# Product Change Notification

<b>Date Issued :</b>	July 31, 2023	<b>PCN Number :</b>	514009
<b>Reason for Change :</b>	Packaging Method/Quantity Changing		
<b>Description of Change :</b>	This notification is to inform you about the following changes that are being made to the packaging of ZQSFP+ SMT Connector . Change: To standardize the packaging for ZQSFP+ connectors, we are moving away from using the corner guides and white bubble form & switching to pink bubble form.		
<b>Assessment of Change :</b>	No change to parts - Form/Fit/Function		
<b>Planned Implementation Date :</b>	January 31, 2024		
<b>Sample Availability Date:</b>	August 27, 2023		
<b>Internal Molex Qualification Date :</b>	August 26, 2023		
<b>Last date to request Samples by Customer :</b>	December 01, 2023

170432\*\*\*\*

## ■ Impacted Products Pictures

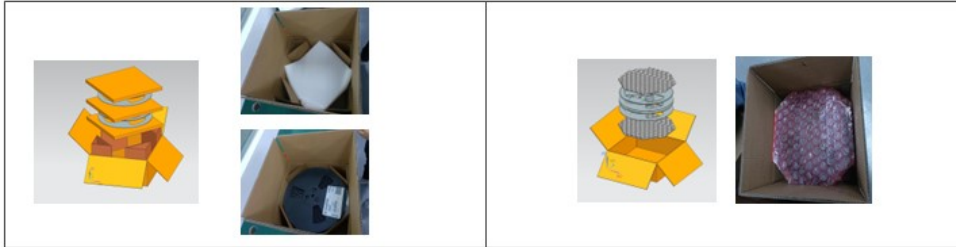
This notification is to inform you about the following changes that are being made to the packaging of ZQSFP+ SMT Connector .

Change: To standardize the packaging for ZQSFP+ connectors, we are moving away from using the corner guides and white bubble form & switching to pink bubble form.

- Drop test is conducted & has passed , reports can be shared upon request .
- There has been no changes made to SPQ/MOQ.

- Product Impact: This changes will have no affect on fit & form, function.
- Part Number Impact: see attached impacted parts list.
